DeKalb County Historic Preservation Commission

Staff Report

K. 1080 Clifton Road, Brian E. Daughdrill. Demolish a historic house, remove a nonhistoric garage, and construct a nonhistoric house. **1248160.**

Subject: **Structural Assessment**
1080 Clifton Rd
Atlanta, GA
CERM Project No. 2025-0862F-017F

Photo 7
Stair-Step Crack (East Wall)

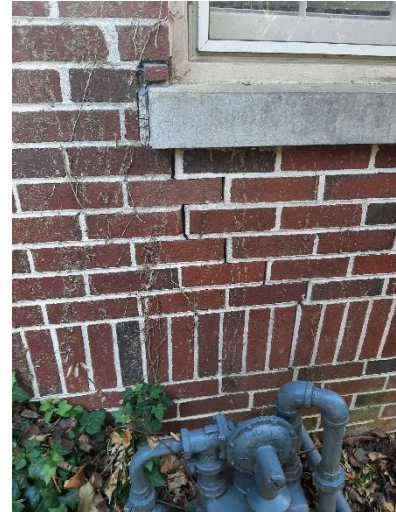
1. General
 - a. Much of the existing structural framing appears sound
 - i. The overall adequacy of the existing framing and connections was not addressed since a structural analysis of existing framing is not included in Sykes' scope of work
 - ii. Most of the damage observed was due to water leaks (from roof / pipes / poor grading / lack of waterproofing)
 - iii. Limited cracking was observed in the plaster finish
 - iv. Beyond the areas of water damage, there was limited peeling paint
2. Observed deficiencies
 - a. The brick veneer above grade appears to be in good overall condition (**Photos 1 through 4**) with the following exceptions:
 - i. Stair-step crack in southeast corner indicating possible foundation settlement. See **Photos 5 through 7**.
 1. Could not access from crawlspace so only observed from exterior

- ii. Loss of mortar / cracked mortar in some locations
 - 1. Ivy / vines growing on the wall can cause damage
- iii. Steel lintels supporting brick above windows show signs of rust, but no significant deflection or damage to adjacent brick
- b. The brick walls below grade appear to be in adequate condition with the following exceptions
 - i. Stair-step crack under window adjacent to driveway. See **Photo 8**.
 - ii. Loss of mortar in some locations. See **Photo 9**.
 - iii. Evidence of water leaks, primarily at windows and piping but some water intrusion / stains at other locations could be due to inadequate exterior waterproofing. See **Photos 10 through 12**.

1. Viable alternatives to demolition, including stabilization include:
 - a. Underpinning at SE corner to mitigate additional settlement
 - b. Waterproofing / upgraded drainage

Roof of Sunroom / Enclosed Porch

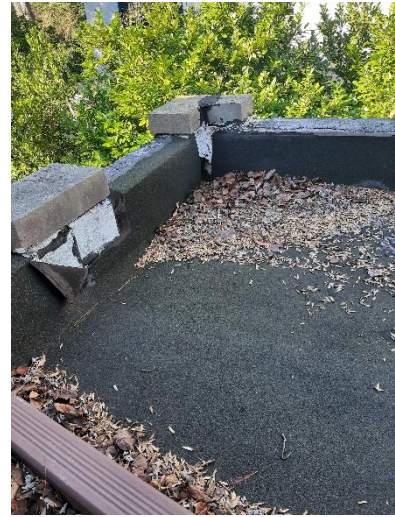
- g. Sunroom / Enclosed Porch
 - i. This area shows the most damage to the structure.
 - ii. The roof over the Sunroom / Enclosed Porch shows extensive signs of water intrusion with damaged and rotten roof joists. The framing over the window on the north side is damaged and rotten with mold growing. See Photos **39 through 42**.

- i. Roof over sunroom would need to be completely redone. There is significant damage to the wood where the roof has leaked
 - b. Sykes recommends a roof assessment for main building. The corner of the roof over the private bathroom on the second floor and the breakfast nook on the first floor shows signs of significant water leaks. This low slope portion of the high roof does not appear to have the typical clay tile that was observed on the rest of the high roof. Damage to the framing from water leaks was also observed at framing near the chimney.

**BASEMENT FLOOR PLAN
(NOT TO SCALE)**

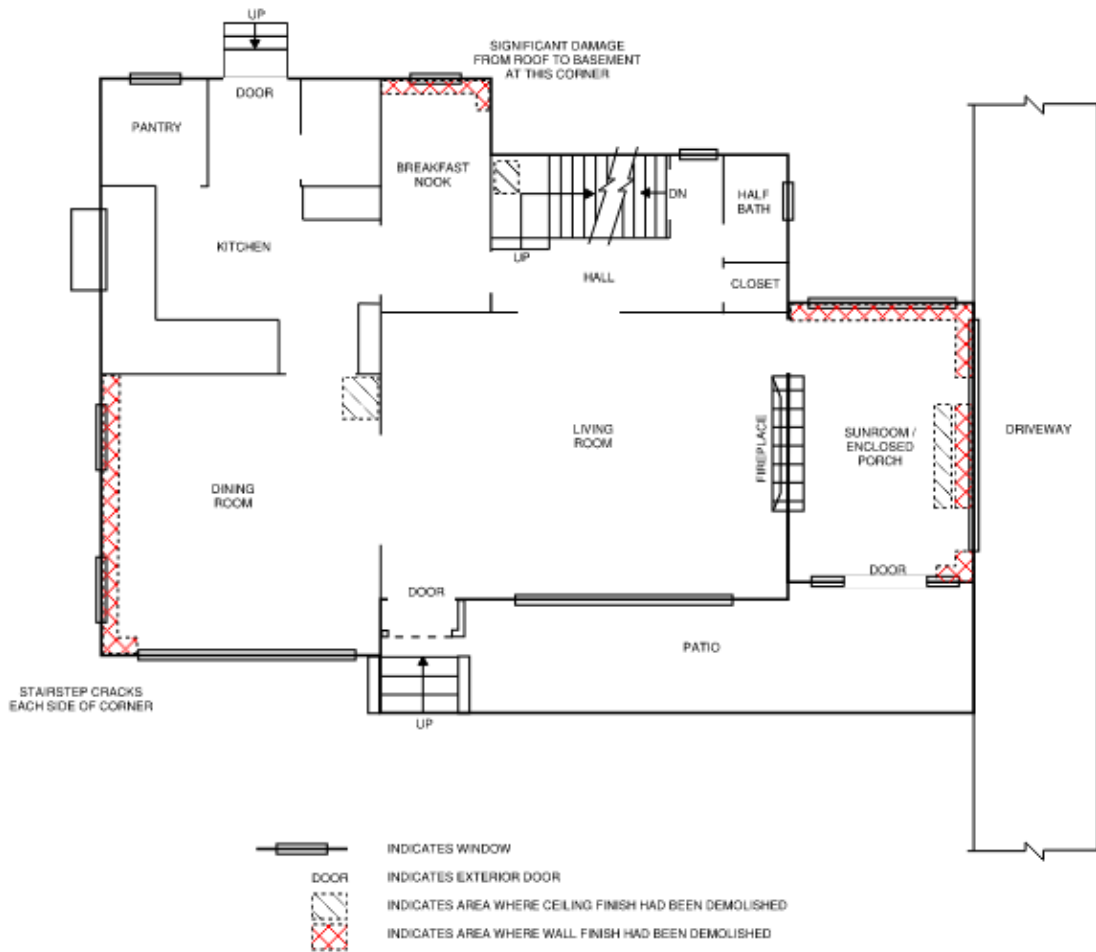
- ii. First floor framing was visible from the basement. See **Photo 25**.
 - 1. Floor joists are supported by wood ledgers. A few joists show cracking at the notch.
 - 2. The ledgers are nailed to beams / rim joists. Some ledgers have slight separation from the support member.
 - 3. There is floor damage directly below the northwest corner of the Breakfast Nook. See **Photo 26**. This damage extends from the roof to the basement in this location.
 - 4. Beams are supported by multiwythe brick or CMU walls, by other beams, or on columns.
 - a. No metal connectors were observed
 - b. The header beam at the stairs has been cut to allow for piping. See **Photo 27**.
 - c. Some beams at the columns show signs of crushing at the column caps. See **Photos 28 and 29**.

2. One column has an adjacent shoring post. The bottom of the beam is at least 1/2 inch above the column cap, so the column is no longer load bearing. A slight indentation is visible where bearing occurred indicating compression of the wood possibly due to inadequate bearing area. See **Photos 29 and 30**.

- f. Foundations / Basement / Crawlspace
 - i. Foundations could not be assessed since they are below grade and would require excavation to expose them.
 - ii. See **Structural Assessment Section 2.b** for exterior multiwythe brick walls below grade.
 - iii. Columns
 1. The bottoms of the columns are rusted. Some are in extremely poor condition with significant loss of section. See **Photos 31 and 32**.
 2. The column foundations are unknown.
 3. One column has an adjacent shoring post. See **Photos 30 and 32**.

- i. The basement wall adjacent to the driveway, the rear of house at basement windows, and the exterior basement entry require particular attention
 - c. Updating first floor framing at posts (replace damaged column and add larger column caps), additional attachments at ledgers, repair at overcut joists
